# Classic Series Basement Door

## Important Replacement Header Instructions

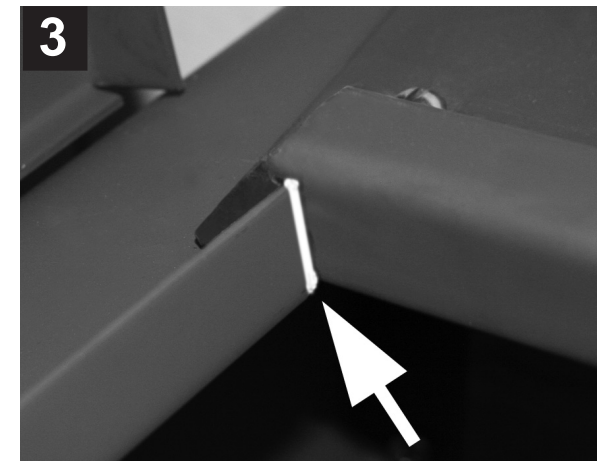
The Classic Series Basement Door has been recently redesigned with a new header. The new header features built-in gussets at each end for enhanced weathertightness as shown in **Figure 1** below.

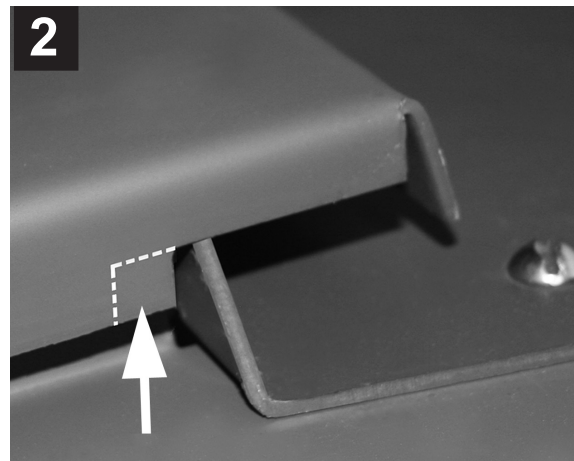
Your replacement header is equipped with the gussets on each end. In some cases, particularly with older door models, there may be some interference between the gussets and the door panels. If you have problems closing your doors once the new header is installed, the door leaves will need to be modified as shown in **Figure 2** below. First, determine the amount of cover material that needs to be removed to clear the header gusset. Remove the material using a metal file or saw as required. Prime and paint areas of exposed metal after door has been modified to prevent corrosion.

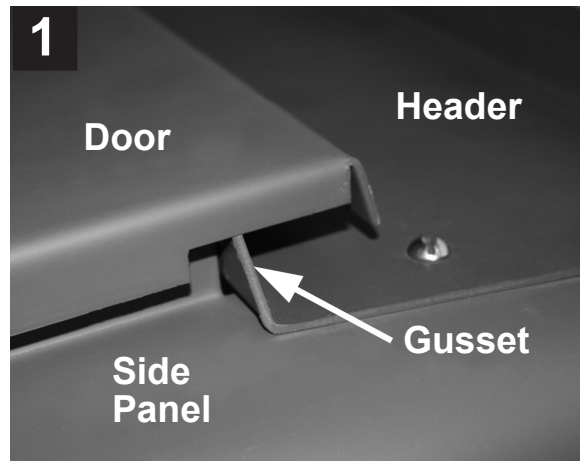
**IMPORTANT:** With header panel fully installed, caulk vertical seam between header and sidepieces on both sides as shown in **Figure 3**. Use exterior grade, paintable, silicone caulk.
